City of Kingston
Report to Kingston Heritage Properties Committee
Report Number HP-24-005

Subject: Application for Heritage Permit

Address: 4156 Highway 2 (P18-042)

File Number: File Number: P18-097-2023

P-W PROPOSED WEST ELEVATION
P-4 3/16" = 1'-0"

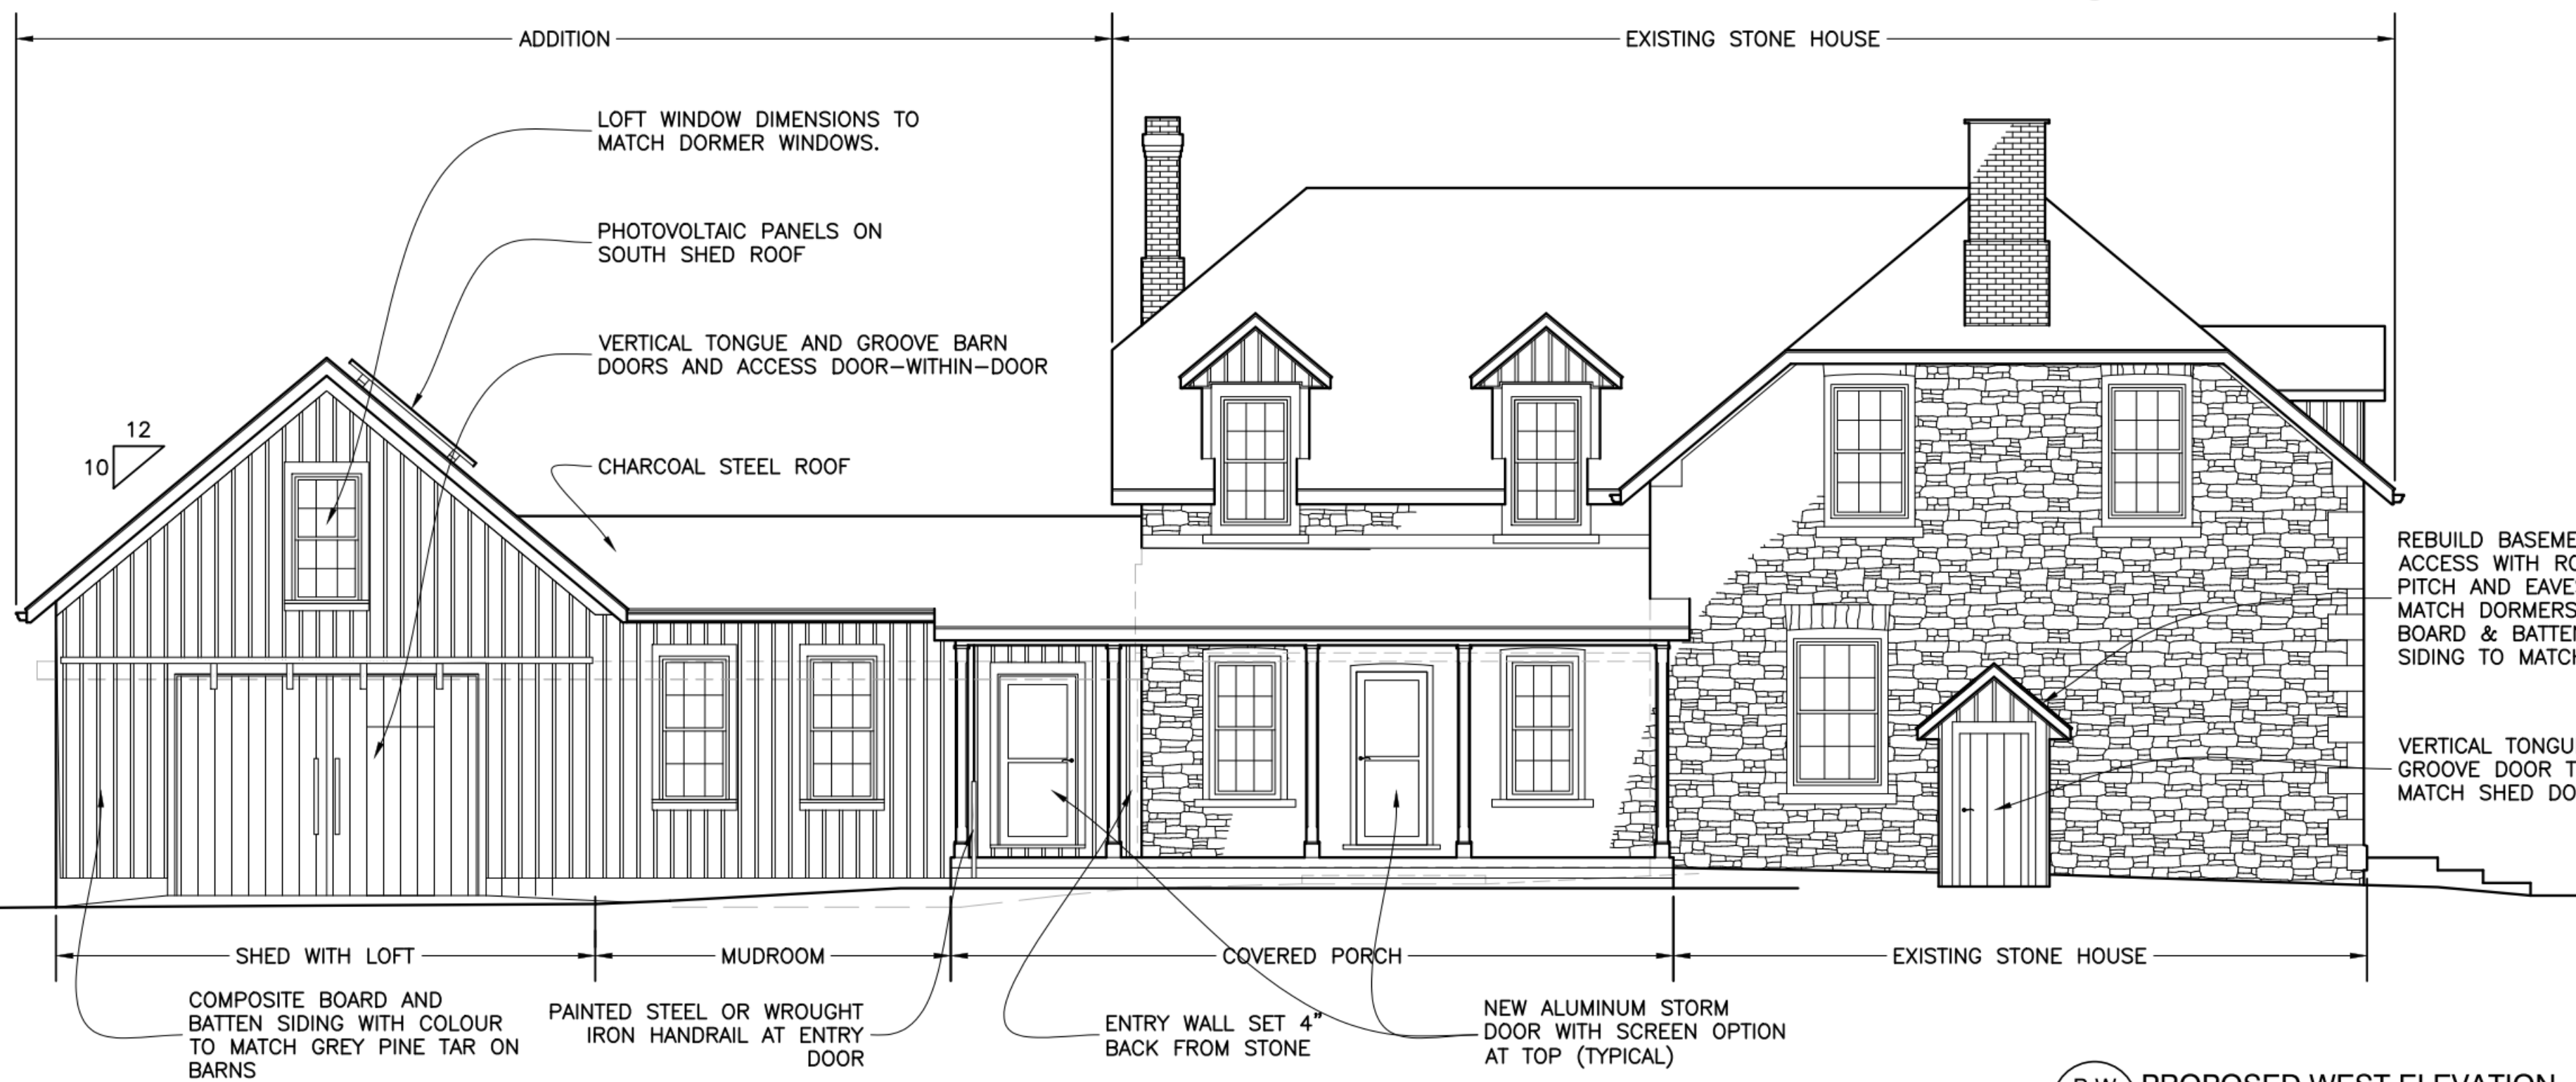
The proposed two aluminum doors on the west elevation and one on the east, should also be reconsidered. More sympathetic to the design would be to source and repurpose old historically appropriate doors or perhaps have half or 2/3 lite 2 over 2 exterior wood doors fabricated along with a removable seasonable screen door for ventilation made to match.

P-E PROPOSED EAST ELEVATION
P-5 3/16" = 1'-0"

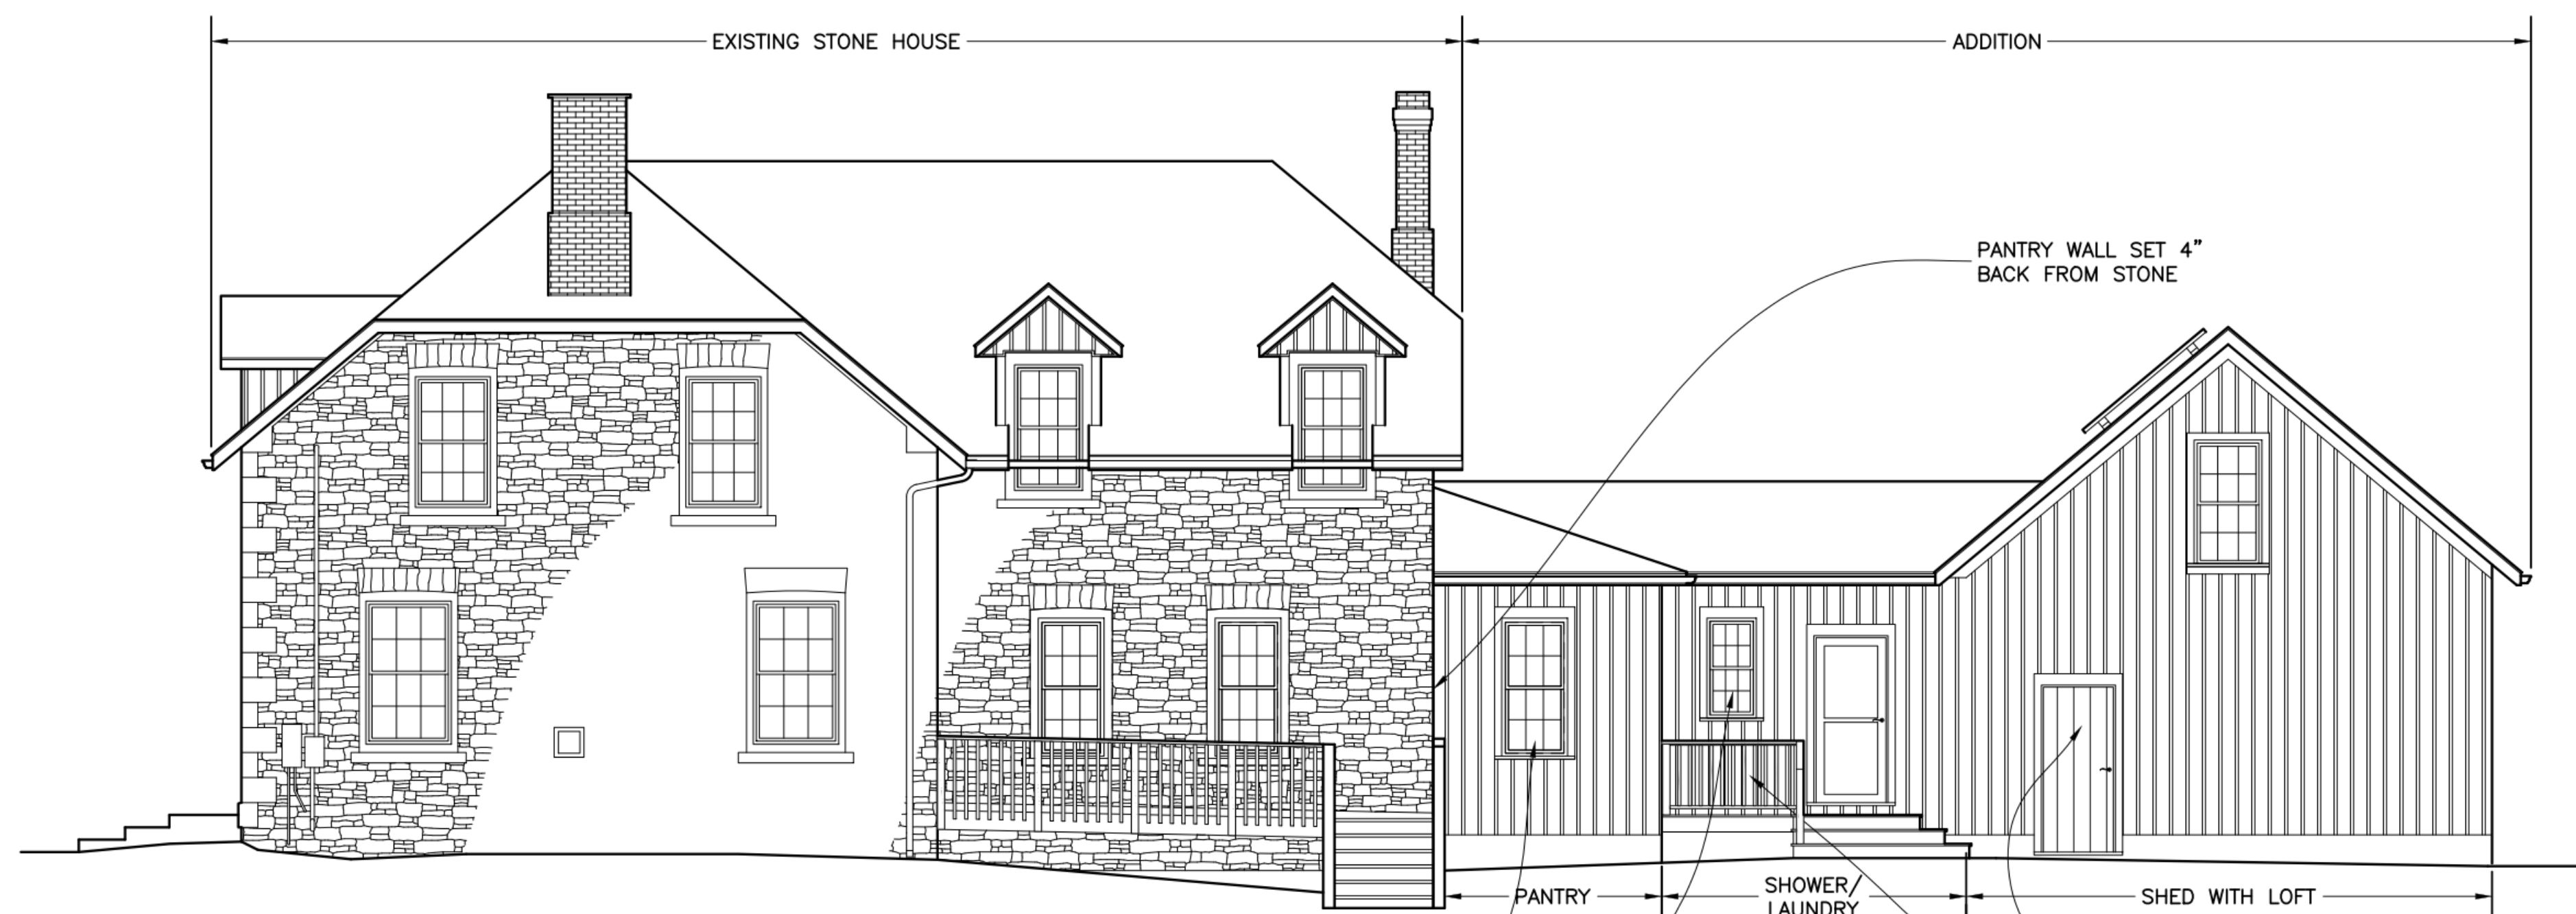
WINDOW SIZE AND HEIGHT IN BATHROOM AND PANTRY TO BE DETERMINED (TO MATCH DOOR HEIGHT OR PANTRY WINDOW HEIGHT). WINDOWS MAY BE CASEMENT OR DOUBLE HUNG AT OWNER'S DISCRETION

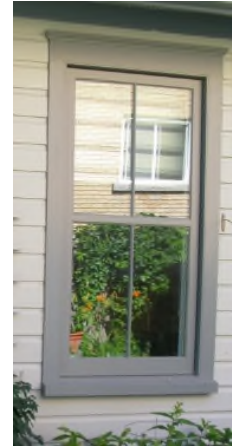
- o The basement access will have the new roofing to match.
- Can a colour sample be provided for the board and batten siding that is noted as grey pine tar finish?

- o The siding for the addition will be a composite material by James Hardie or similar (<https://www.jameshardie.ca/>) with dimensions and factory applied colour to match the grey pine-tar finished board and batten siding of the barns (pine tar vitriol from Sage Restoration: <https://sagerestoration.com/collections/pine-tar/products/grey-pine-tar-vitriol?variant=13684113604654>).

- o A photo of the existing barns is included below and a close-up of the siding colour on the right.

- Samples of possible colours will be requested from the manufacturer(s) so that the owners can compare them to the barns on site for the most accurate match. The samples and/or photos of them against the barn siding can be provided at that time.
- Regarding the solar panels, how many will be added and how much will they project off the roof?
 - There will be 6 portrait orientation (or 8 landscape orientation) panels measuring 64.5" x 38.5".
 - The racks are approximately 5" high.
 - Photos of solar panels on the big barn are included below. They pretty much disappear against the dark roofing, particularly from a distance.

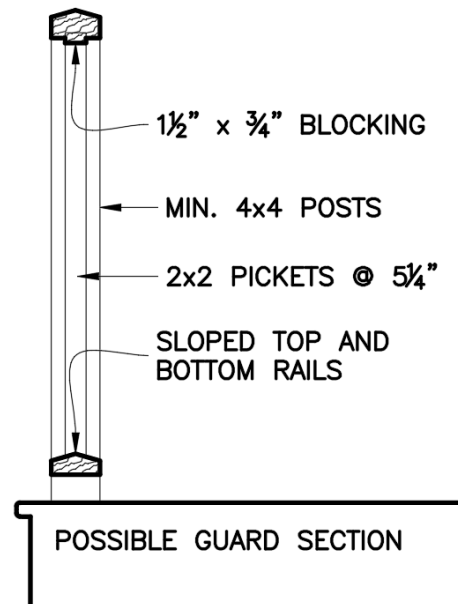
- Can additional information be provided on the guards and handrails? What will their colour/finish be? What is their design/spacing? Even examples that generally show what is proposed can be helpful.
 - We are trying to avoid any new guards and are hoping to raise the grade sufficiently at the back deck that they won't be required.
 - If a guard is necessary, it will not match the ones on the existing deck, which are minimum building code guards without a bottom rail. A simple guard with sloped rails and infill pickets is the likely choice for the guard itself.

- The newel posts and handrail are still at the design stage. These, and the porch columns, are an opportunity for the owners to put their own creativity and craft into the details, as illustrated by the preliminary sketches below.
- As any designer knows, details like this take time to develop, and can include historical research and perhaps even finding original examples of the same vintage as the house at architectural salvage companies like Legacy and Balleycanoe for reuse, inspiration or replication. The owners have the tools and skills to turn wood, and can make the new porch a very special addition to the house.
